SERVICE INFORMATION LETTER

SIL21-04B

SUBJECT: Improved Rocker Cover Gasket, Part No. 668893

PURPOSE: Announce new part number availability and important installation instructions

Figure 1. Gasket Comparison

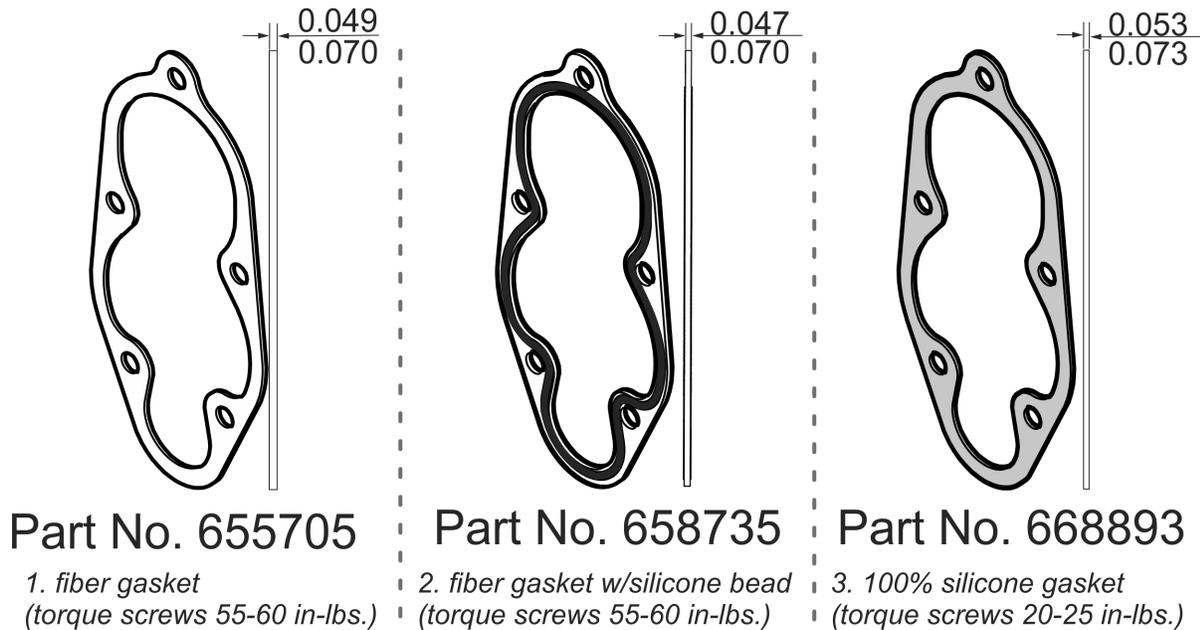
A new silicone rocker cover gasket Part No. 668893 has been placed in production for the crossflow engines listed above. Part No. 668893 gasket supersedes gasket Part No. 658735. The silicone material provides a more flexible seal than the previous gasket, when properly installed.

Rocker Cover Gasket Part No. 668893 is a flexible, silicone gasket, smooth on both sides; no special mating instructions apply. Rocker Cover Gasket Part No. 658735 is a fiber gasket with a silicone bead on both sides of the gasket. Gasket Part No. 655705 (preceded Part No. 658735) and previous gaskets used with crossflow style cylinders were fiber gaskets with no bead. Earlier gaskets were subject to age control; Part No. 668893 is not.

Figure 2. Rocker Cover Installation

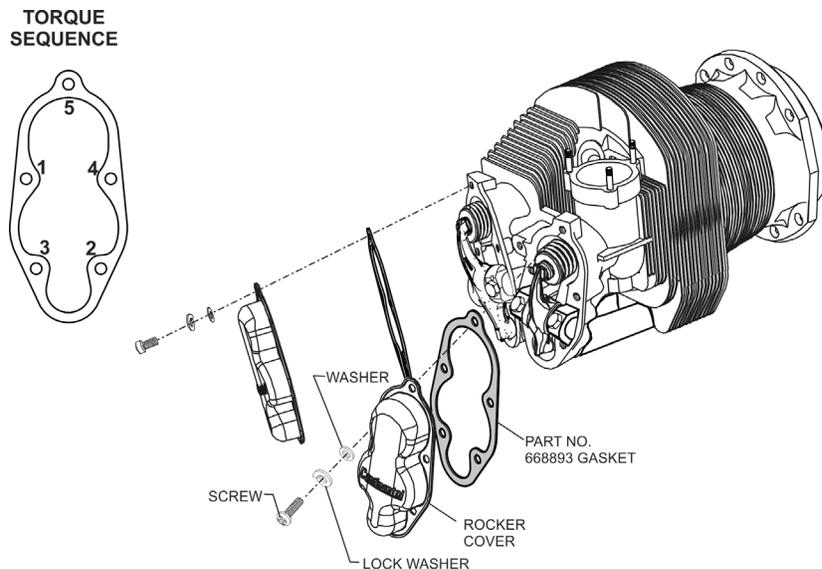
CAUTION: Failure to clean the rocker and cover flanges will cause leaks. Surfaces must be clean and oil-free to seal properly. Applying 55-65 in-lbs. torque to rocker cover fasteners using Rocker Cover Gasket Part No. 668893 will damage the gasket and rocker cover.

1. Clean the rocker box (including threaded screw holes) and cover flanges thoroughly with isopropyl alcohol (IPA) or acetone before installing the gasket to remove oil and old gasket residue. Clean the rocker cover screw threads with a wire brush and rinse with IPA or acetone.
2. Install rocker cover(s) with new gasket according to instructions in the primary ICA.
3. Sparingly apply a thin bead of Continental Part No. 658517 (Loctite® 243) across the rocker cover screw threads according to the manufacturer's instructions. Secure each rocker cover with five screws and torque the screws in an alternating pattern (see Figure 2):

- a. On rockers using gasket Part No. 668893, torque cover screws 20-25 in-lbs.
- b. On rockers using any fiber gasket, torque cover screws 55-60 in-lbs.
